ADDENDUM  
PURCHASING OFFICE  
CITY OF AUSTIN, TEXAS

REQUEST FOR PROPOSAL NO: OPJ0107 ADDENDUM NO. 3 DATE OF ADDENDUM: OCTOBER 28, 2013

<p><b>M.I.O.</b></p>	<p><b>DOMAIN - NEW 2500 TON CHILLER INSTALLATION</b>  <b>DOMAIN DISTRICT COOLING PLANT/AUSTIN ENERGY</b>  <b>CLM089 2012 M.E.P. Rotation List PA120000006</b>  <b>D.O. NO. 13071517369</b></p>	<p>ASHTX TEXAS 78708</p>	<p><b>Jose J. Guerra, Inc.</b>                  Consulting Engineers, Inc.                  8401 South IH-35 Suite 210                  Austin, Texas 78741                  (512) 441-8006                  Structural &amp; Civil &amp; Mechanical &amp; Electrical                  TSP2 FORM F-3</p>
----------------------	--	--------------------------	--

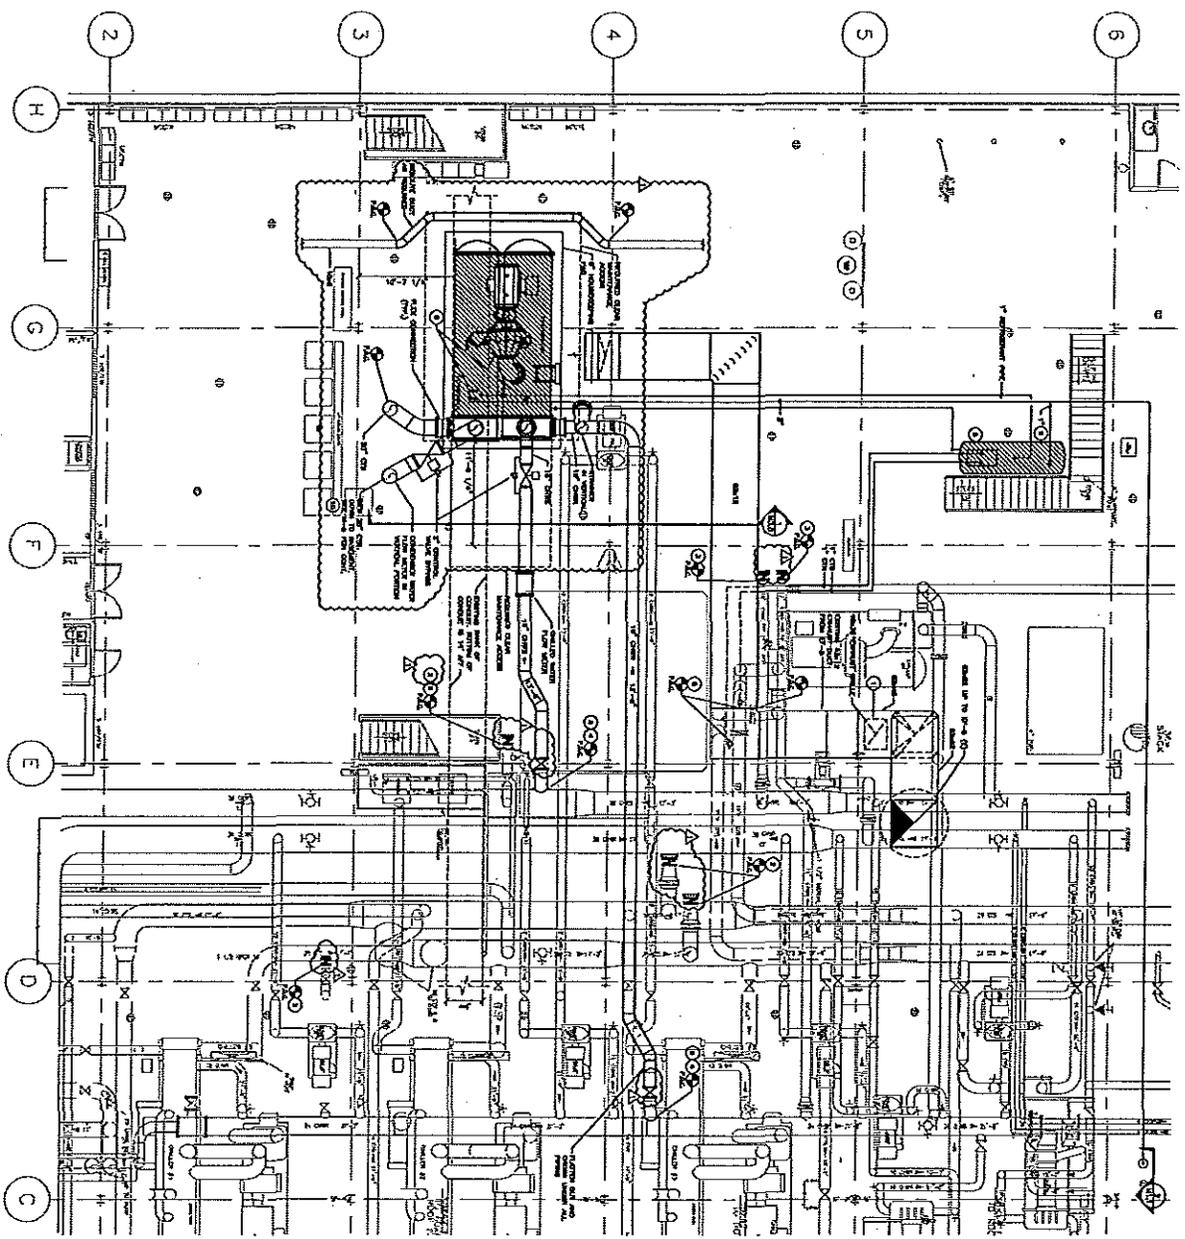
5. 1M1.1 requires the new chilled water piping to be connected to the existing CHW piping mains using a Wet tap. The butterfly valve depicted at the point of connection (POC) of the new piping to the existing will not permit wet tapping as is required of the contract documents.

**Please verify that the butterfly valves are to be changed out to gate valves.**

12. Keyed notes 2 & 3: requires the flange bolted to the new valve is to be welded to a piece of pipe which is then capped. *It is common practice to bolt a blind flange directly onto a lugged style BF valve in lieu of what is being required of these keyed notes.*

**Please verify that a blind flange bolted onto the new valve will not be acceptable.**

13. Keyed note 5 on M1.1 requires the piping connections to the main to be made at 30°. Can the piping connection be made at 45° to avoid the modification of a 45° fitting?

16: When looking at plans what supersedes? For example, M1.1 keynote 2 states : "weld a flange to existing pipe and cap". However, on the plans they show an additional butterfly valve in place.

**Valves associated with the hot taps are to be gate valves. Drawing will be changed in addendum.**

**Blind flange to lugged BF valve is acceptable. Drawing will be changed in addenda.**

**45 degrees is acceptable**

Note 2 will be revised. For capped pipes, a new lugged butterfly valve will be required with a blind flange bolted to it. For wet taps, a gate valve will be required.

- A. Flex connections shown for clarity.
- B. 2 valves revised from butterfly to gate.
- C. Capping system of existing pipe legs revised to include a blind flange bolted directly to valve.
- D. Chiller moved 25” to plan East.
- E. Notes 2,3, 5 and 6 edited as indicated.
- F. Showed existing 10x6 duct to be relocated.

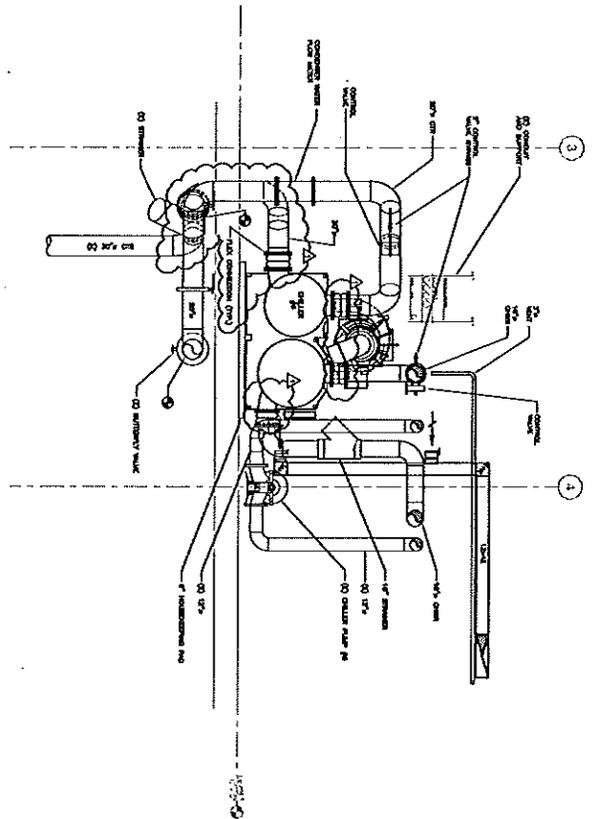
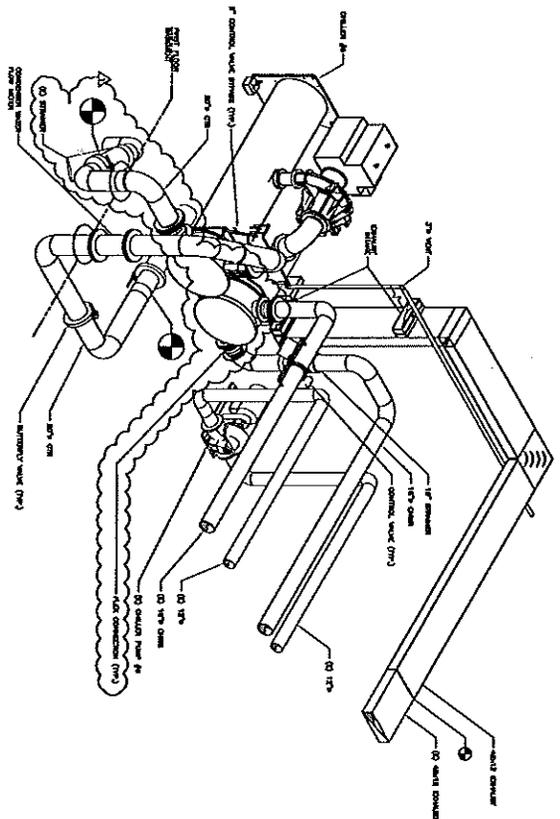
8. The 2" bypass at the control valves is depicted on 1M2.0 & 2M2.0, but not on 1M1.1. Please verify that this 2" bypass is in-fact required at the control valves.

9. 1M2.0 depicts the use of short radius (SR) 90° elbows in the CWS & CWR piping. Please verify that the use of SR 90° elbows is indeed required for this project; or, is it the intent of the contract documents that the SR 90° elbows are to be used whenever the piping fit-up (in confined spaces) requires its use.

**2" bypass is required**

**Use short radius elbows only where required. Note: short radius elbows may be required near flow meters to maintain manufacturers recommended distance of straight pipe.**

A. Revised details to match plans as indicated.

PROJECT TITLE  
 PROJECT NO.  
 130366.30  
 SHEET NO.  
 S2.0

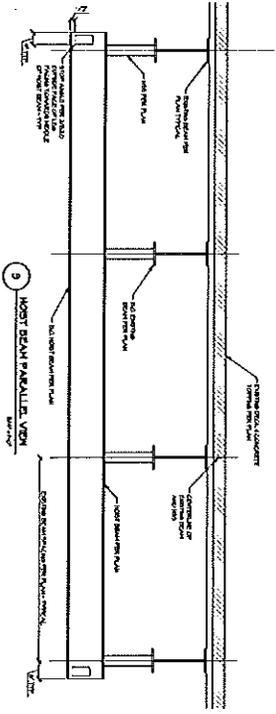
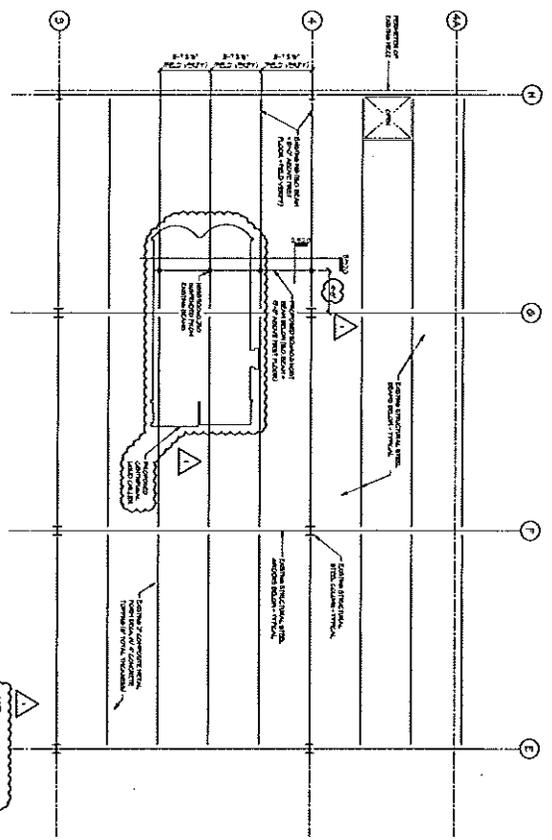
14. Drawing 1S2.0: requires the provision of a new structural steel beam, the bottom of which is to be installed 15'-8" AFF and 6'-9" west of column G. The specified dimension off column 'G' places the I-Beam above an existing rack of conduit, which will render the trolley useless if the conduit is not relocated?? Please review and address direction to be taken by the contractor (also, if conduit is to be relocated, would that relocation need to be provided on overtime?).

**Chiller is being moved slightly to plan East to allow motor removal without interference of conduits. Drawing will be changed in addenda.**

A. Relocated hoist beam and chiller as indicated
